Item ID: D5162-041 Accept ***N900040100*** Setup Start ***NS1***
Revision ID: Stop ***NS2***
Item Name: Seat Structure Assembly
Start Date: 11/30/2015 Start Qty: 1.00 ***1*** Cust Item ID:
Required Date: 11/30/2015 Req'd Qty: 1.00 ***1*** Customer:
Reference:

DESIGN <i>CP</i>	DRAWN BY <i>CP</i>	DART AEROSPACE LTD HAWKESBURY, ONTARIO, CANADA	
CHECKED <i>#</i>	APPROVED <i>#</i>	DRAWING NO. D3016	REV. A SHEET 1 OF 3
DATE 01.05.18		TITLE SEAT FRAME ASSEMBLY	SCALE NTS
A	01.05.18	NEW ISSUE

DRAWING NO. D3016	TITLE SEAT FRAME ASSEMBLY	REV. A	DART AEROSPACE LTD ENGINEERING ORDER	D.E.O. NO. D3016-A-1	SHEET NO. SHEET 1 OF 1	SCALE NTS
DRAWN <i>1</i>	CHECKED <i>1P</i>	MFG. APPR. <i>RE</i>	APPROVED <i>MP</i>	DE APPR. <i>1P</i>		
DATE 10.01.29	DATE 10.01.29	DATE 10.01.29	DATE 10.01.29	DATE 10.01.29	DATE 10.01.29

D3016-11 SADDLE

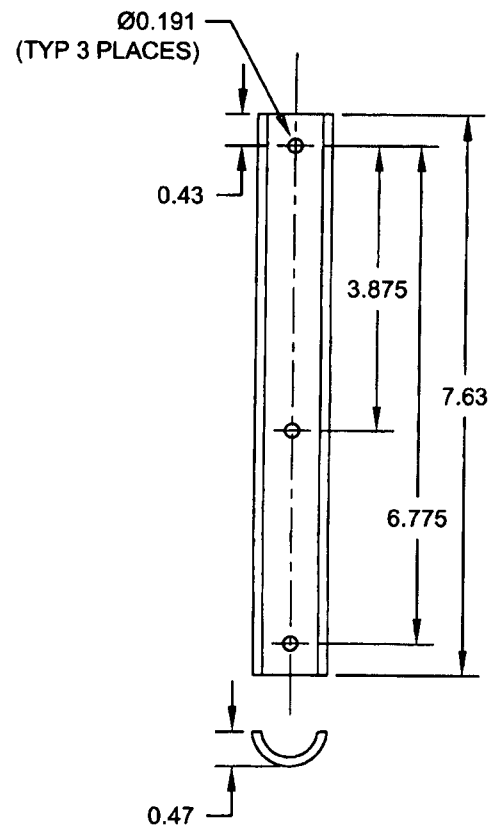
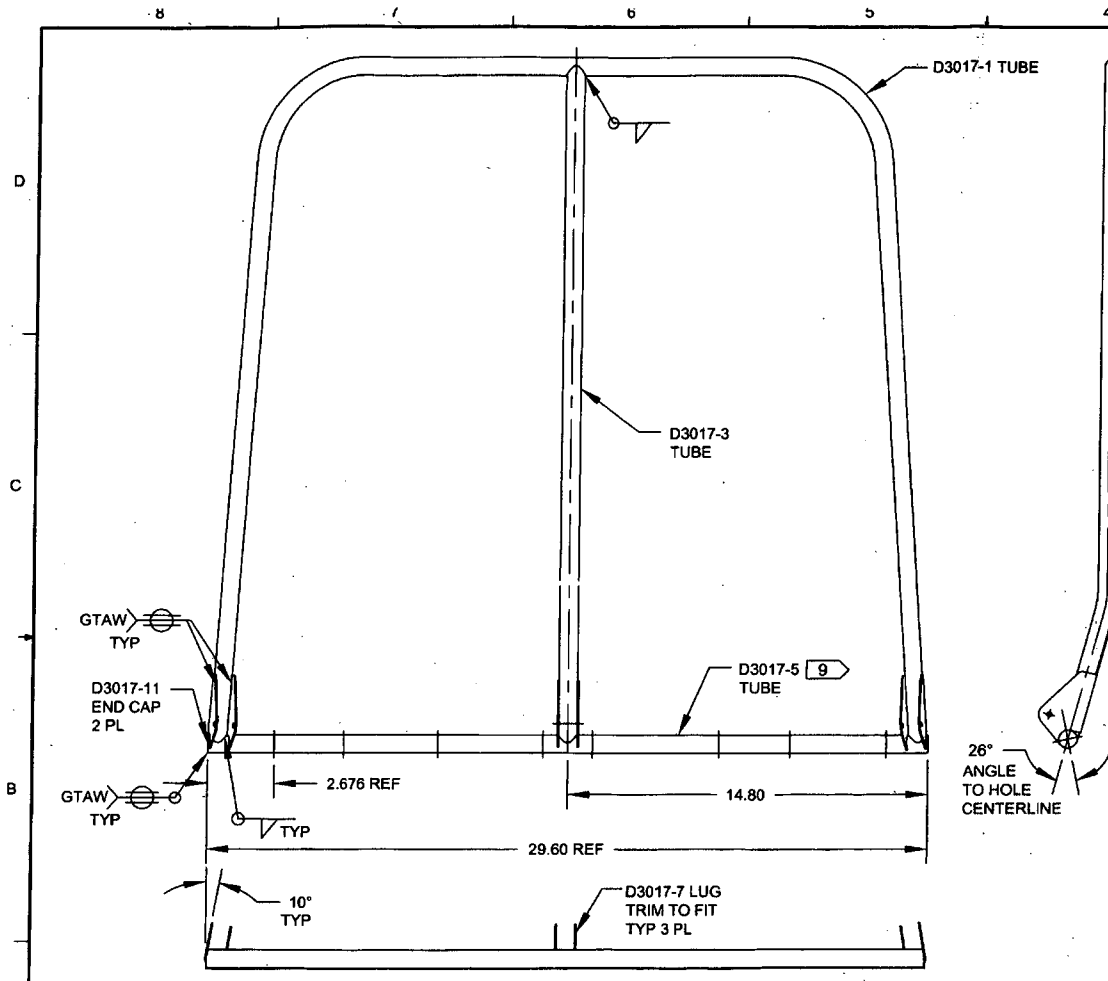
PURPOSE:

TO REVISE D3016-11 SADDLE'S HOLE SIZES

DETAIL D3016-11 SADDLE (SHEET 3): Ø0.257 TYP 3 PL WAS Ø0.191 (TYP 3 PLACES) AS SHOWN:

IS:

WAS:
